Item ID: D204-635-041

Item Name: Replacement Skidtube

DRAWING NO. D2590	TITLE 204 SKIDTUBE ASSEMBLY	REV. E	DART AEROSPACE LTD ENGINEERING ORDER	D.E.O. NO. D2590-E-1	SHEET NO. SHEET 1 OF 1	SCALE NTS
DRAWN <i>gp</i>	CHECKED <i>ASS</i>	MFG. APPR. <i>BE</i>	APPROVED <i>MD</i>	DE APPR. <i>MD</i>		
DATE 11.12.13	DATE 11.12.13	DATE 11.12.13	DATE 11/12/13	DATE 11/12/13

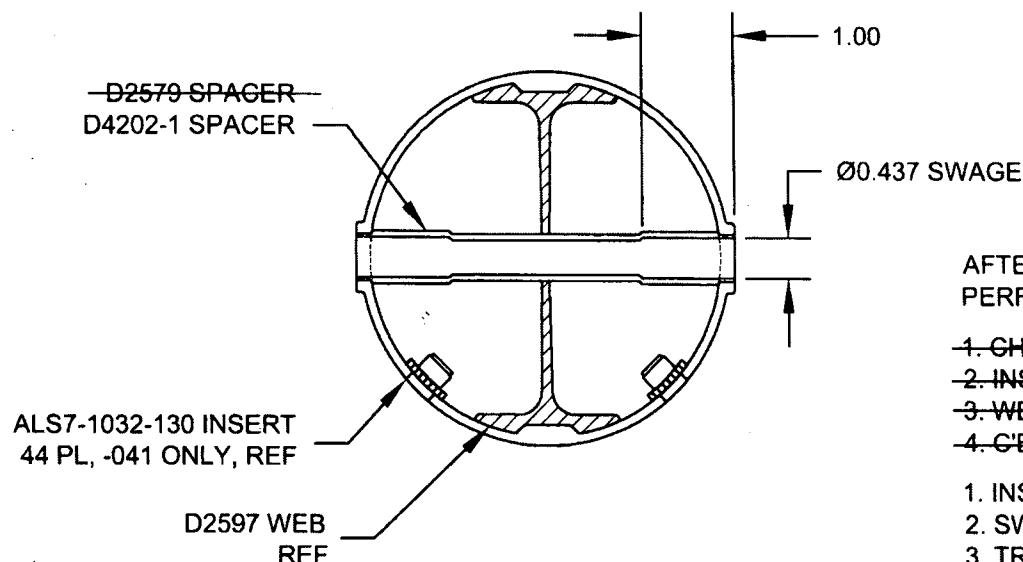
CHANGE ALL WELDED CROSSBOLT SPACERS TO SWAGED SPACERS

SECTION B-B & F-F IS AMENDED AS FOLLOWS:

17	22	D4202-1	SPACER
----	----	---------	--------
